PROPOSED RESIDENTIAL DEVELOPMENT
59 CUDGEGONG ROAD ROUSE HILL, NSW 2155

SITE 1

DEVELOPMENT APPLICATION

SHEET TITLE:
LEVEL 2
DESIGN:
NS
DRAWN:
AJRSA
DATE:
JUNE 2016
SCALE:
AS SHOWN

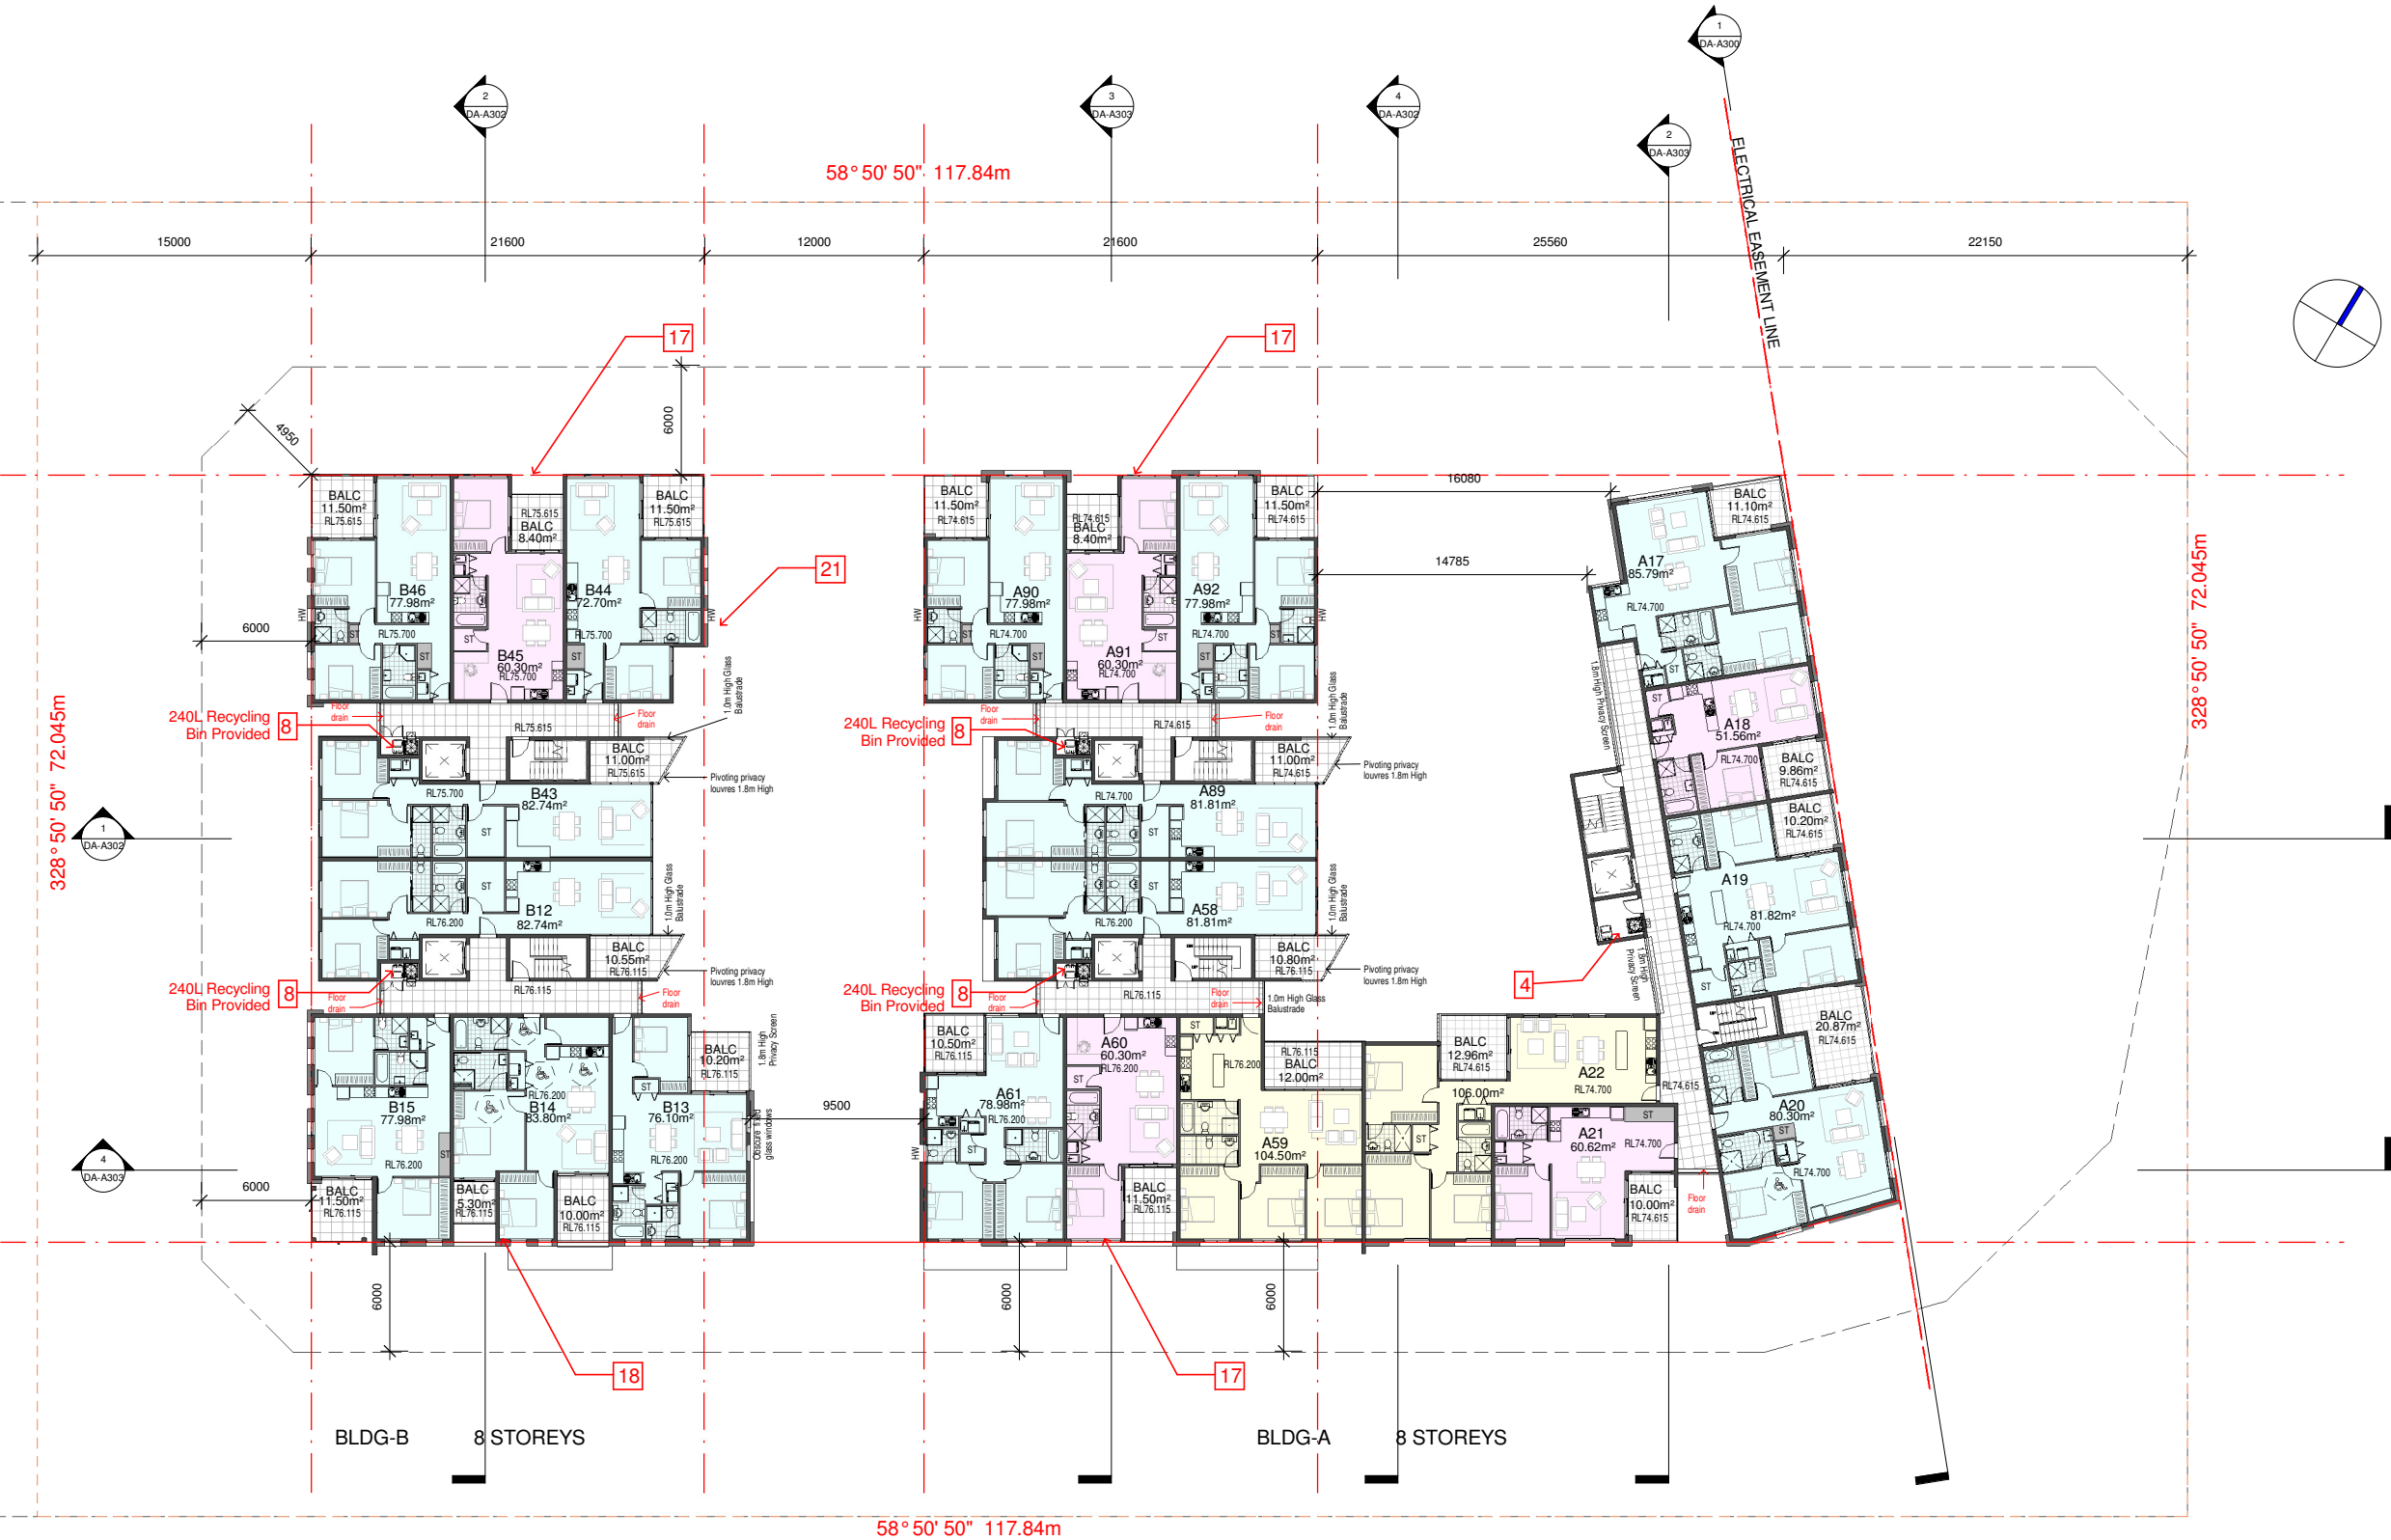
1. Bin travel path with 1.5m wide provided at basement.
- 2.Removable bollards and a no parking line mark noted.
- 3.Truck sweep paths of 11.00m long council truck provided.

- 4.Building-A residents access to recycling bins located at the top of the stair well and adjacent to the lift core from Level 1 and above added.
- 5.Waste room access adjacent to the driveway ramp relocated.

- 6.1.5m wide doorway provided in each bulky waste storage areas and caged enclosure.
7. Driveway ramp gradients adjusted.
8. 240L recycling bins provided

- 9.Access between bulky goods and waste bin room deleted.
10. Fire stair relocated
- 11.Lift relocated and Waste room and bulky storage adjusted.
- 12.Relocate lift, fire stair adjusted and relayout of car and bicycle parkings.

- 13.Waste room and bulky storage adjusted.
- 14.Relocated lift core and car and bicycle parking adjusted.
- 15.Fire stairs adjusted and relocated door access openings.

- 16.Redesigned Building A to achieved solar access requirements to the communal open space. Fire stairs and lift relocated,access ramp added to access COS and redesigned of the unit layouts.

17. Redesigned of unit layout
A61,A65,A69,A73,A77,A81,A85,A92,A96,A100,A104,A108,A112 and A116.
- 18.Redesigned of unit layout
B06,B10,B14,B18,B22,B26,B30,B41,B45,B49,B53,B57 and B61.

- 19.Building A roof plan adjusted and roof overhang deleted.
- 20.Skylights provided on Unit A45,A76,A77,B30& B31 but is not included in the solar calculation that recieved minimum 2hrs of sunlight.

- 21.Adjusted unit layout
B36,B40,B44,B48,B52,B56,and B60
22. Adjusted layout-bulk storage and waste room
23. Adjusted bin layout
